Somerset Marketplace

PLANNING REPORT #7-05

RE: Somerset Market Place
Response to Traffic Comments

Drawing Name: **Other Development**

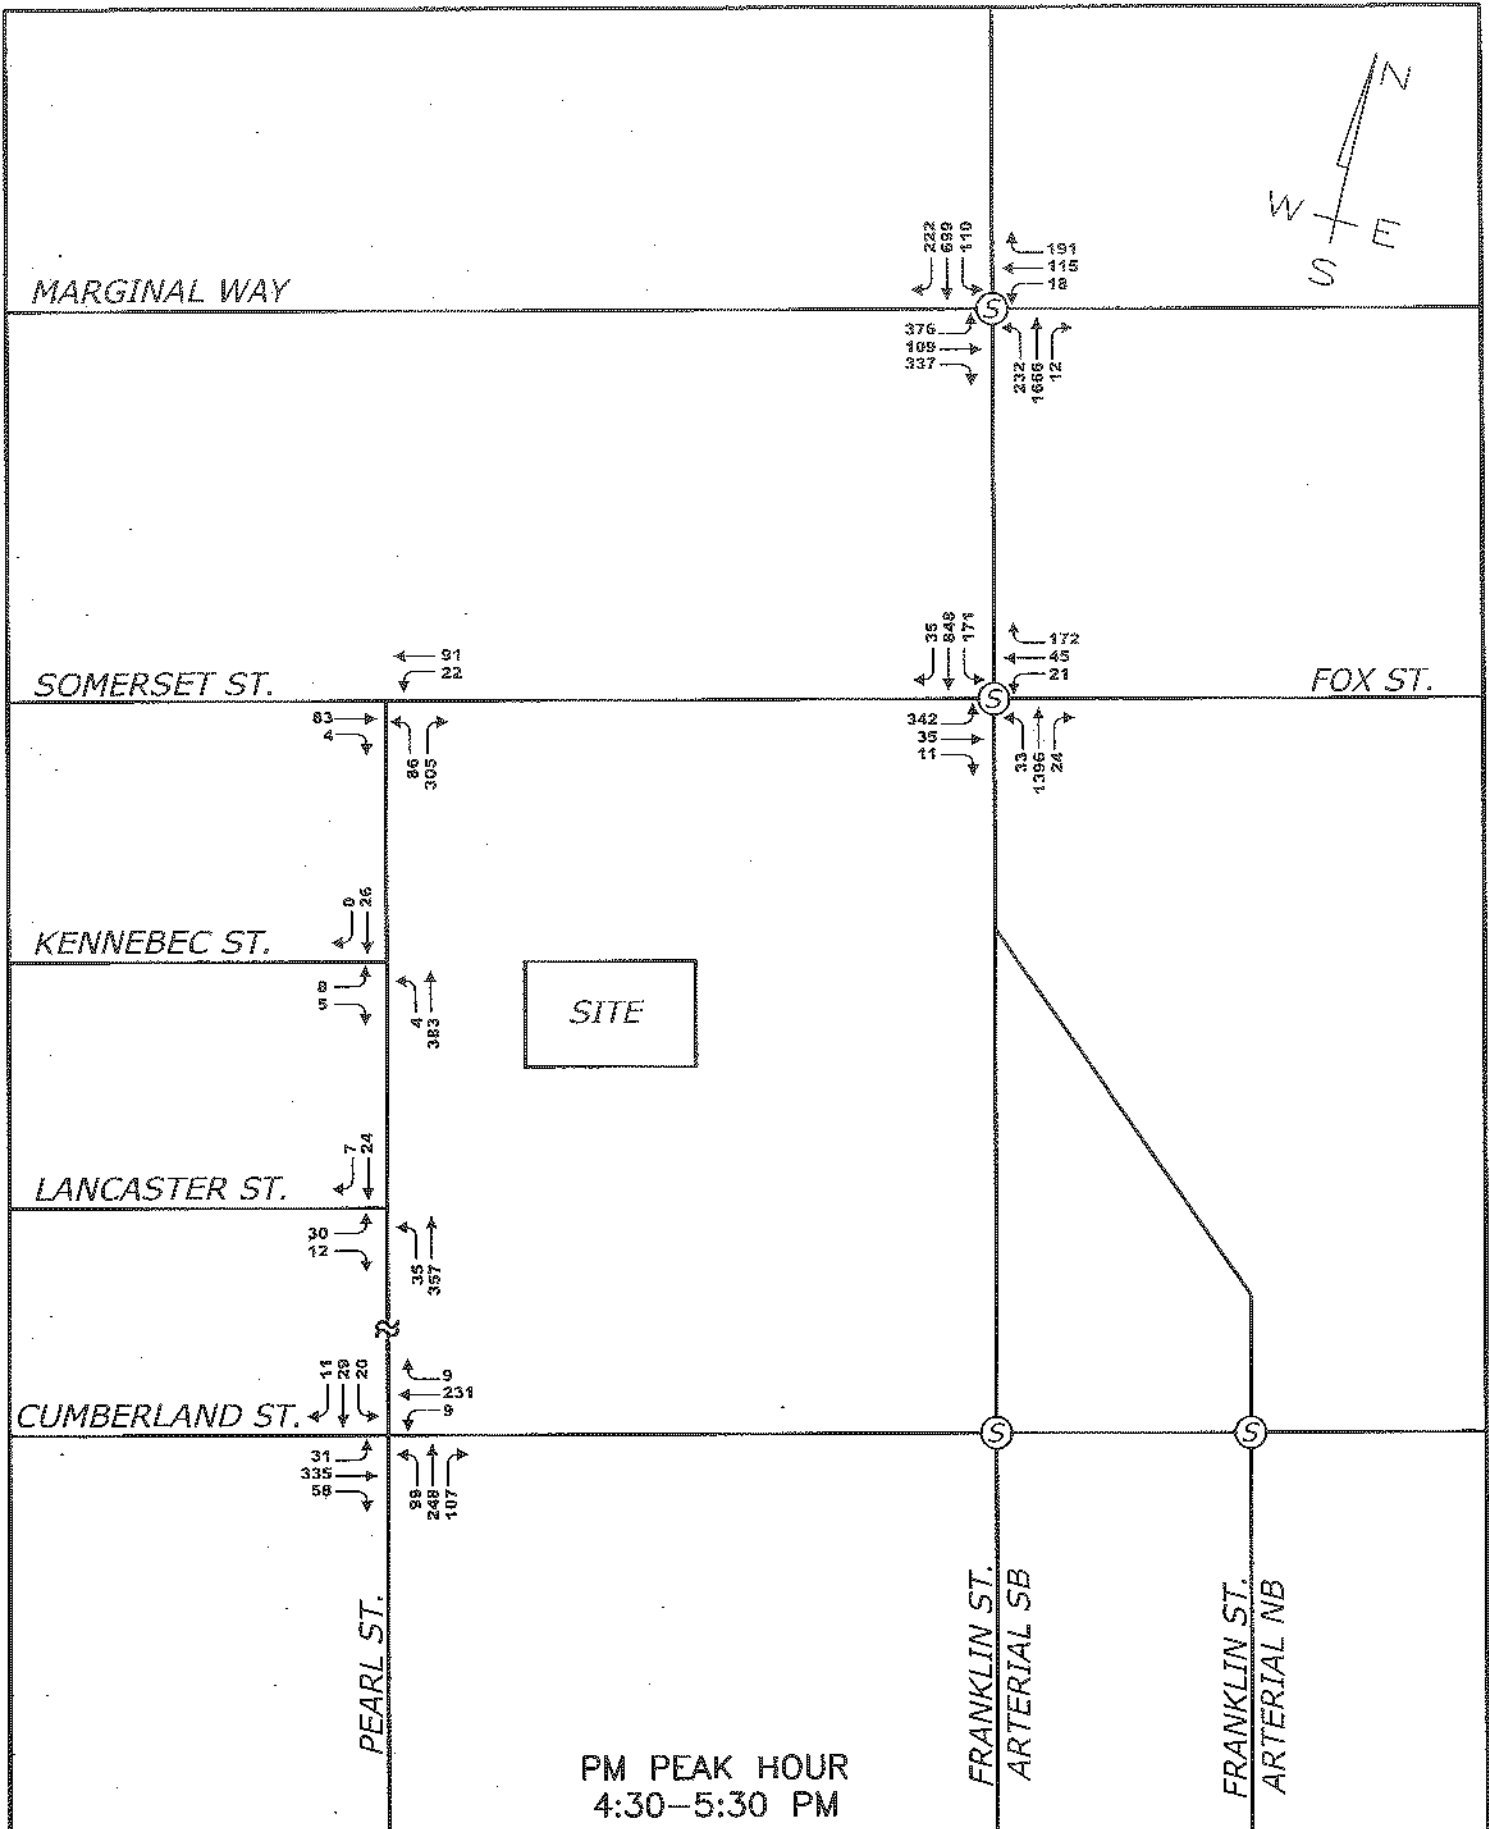
Comment 3 – I was surprised at the estimate of traffic volume that is projected to turn left from Chestnut Street onto Marginal Way. Can you provide some documentation on how this was derived? Is this connection in the PACTS model? It may be helpful to get Kevin Hooper to provide the data.

Response – Based on a conversation with Kevin Hooper, the volumes at this location not only include assignment of traffic from nearby streets, but also traffic from the Bayside redevelopment plan. Based on Kevin's comments, the turning volumes at the intersection were halved to reflect volumes for the current development levels of Bayside. This change does not have an effect on the relocation of existing volumes from Franklin Street Arterial. The "other development" sheet has been revised to reflect this change.
